**RE: 2018 NC Building Code, Section 420.2 and 708.3, Exception #2
Use of 30-min. Horizontal Assemblies Between Group R3 Dwelling Units and Mixed Occupancy**

This letter is in response to your request for formal interpretation dated January 3, 2020 that was received by NC DOI by email to Cliff Isaac. In my words you are requesting:

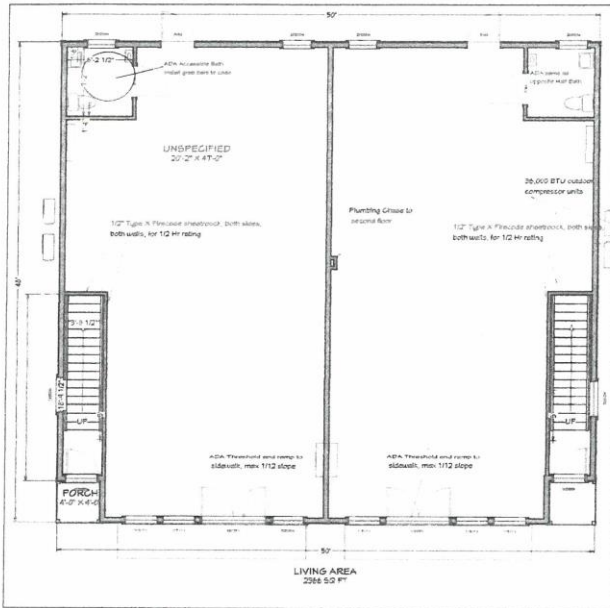
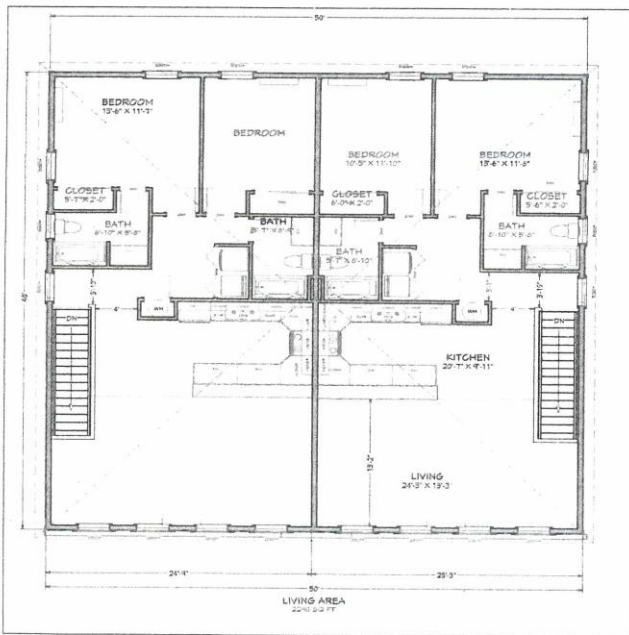
The first floor has two Use Group B units of 1128 sq ft each.

The second floor contains two Use Group R-3 residential units of 1152 sq ft each.

The ceiling between the two floors is a horizontal assembly with a ½- hour fire-resistance-rating.

The wall separating the two residential units is a fire partition with a ½- hour fire-resistance rating.

The first floor B units are to be protected with a NFPA 13 fire sprinkler system

The second floor R-3 units are to be protected with NFPA 13D or Section P2904 fire sprinkler system

We have a 1/2 -hour rated assembly separating the dwelling units from each other and from the Group B use.

If NFPA 13D sprinklers are used in the Group R-3 dwelling units and NFPA 13 sprinklers in the nonresidential occupancies (Group B in the case), the Group R-3 dwelling units on the second floor must be separated from the Group B occupancy on the first floor with a 2-hour fire-resistance-rated horizontal assembly (floor ceiling assembly).
